MARSHALL AEROSPACE AND DEFENCE GROUP SERVICE BULLETIN SBM-197

INTRODUCTION OF MODIFICATION KIT T67A-05-1992 (MA1992)

This page transmits Initial Issue 1 of Service Bulletin SBM-197

Figure 1 - Firefly Rudder Pedal at Rudder Cable to Rudder Pedal Interface

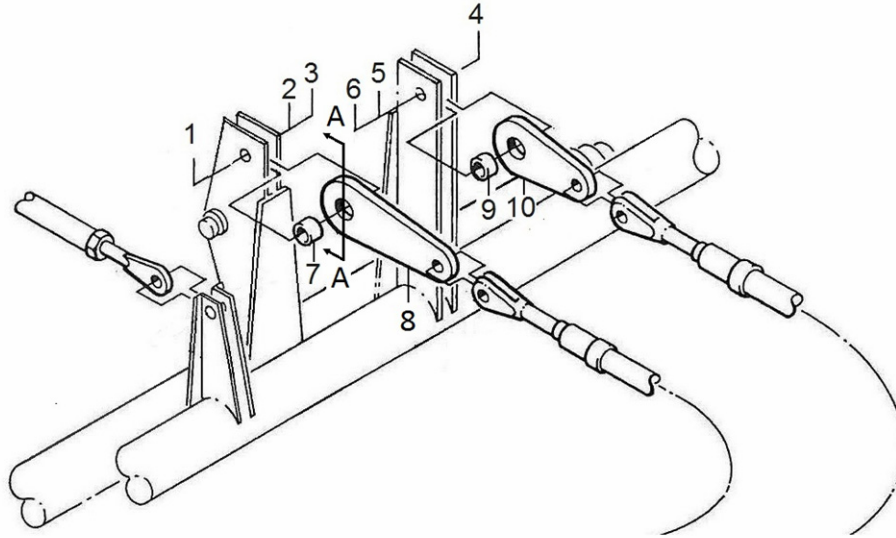
Refer to Figure 1.

CAUTION: When disconnecting the rudder link plates (8) (10), take care to retain the cable plate spacers (7) (9).

- (1) Remove nuts (3) (6), washers (2) (5) and screws (1) (4) that attach the two rudder cable link plates (8) (10) to the two rudder pedal bars.
- (2) Discard items (1) (2) (3) (4) (5) (6).

- (3) Attach the two rudder cable link plates and spacers to the rudder bar with the two low pan head bolts (T67M-45-0579), washers (126-23-103) and slotted nuts (126-22-113) provided in Modification kit T69A-05-1992 ensuring the bolt heads face outboard.
- (4) Tighten the slotted nuts (126-22-113) to 6.5 Nm.

Figure 2 - Drill Hole Position  
Typical 2 Positions

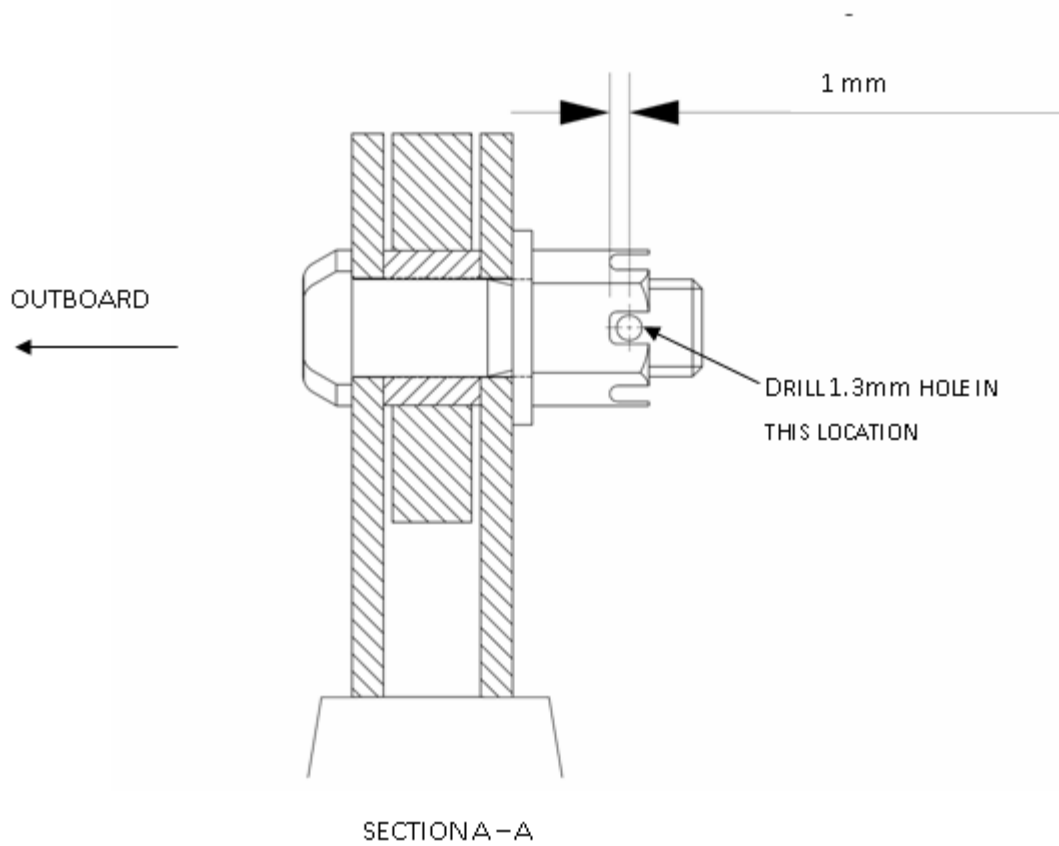
- (5) Check clearance between bolt head and rudder pedals i.a.w. SB 187 (Issue 6) and SB 188 (Issue 6) as applicable. If clearance is still below required minimum, check that pedals are setup correctly. If clearance is still below minimum, inform Marshall ADG.
- (6) Referring to Figure 2, mark the drill hole position in each bolt.
- (7) Drill a 1.3 mm hole in the marked location in each bolt.

**NOTE:** Bolts can be removed from assembly for drilling purposes. When re-assembling ensure bolt heads face outboard and the nuts are tightened to 6.5 Nm. The hole and slot are to be aligned.

- (8) Install the split pins in the drilled holes and form the split pin legs and cut to length as required.
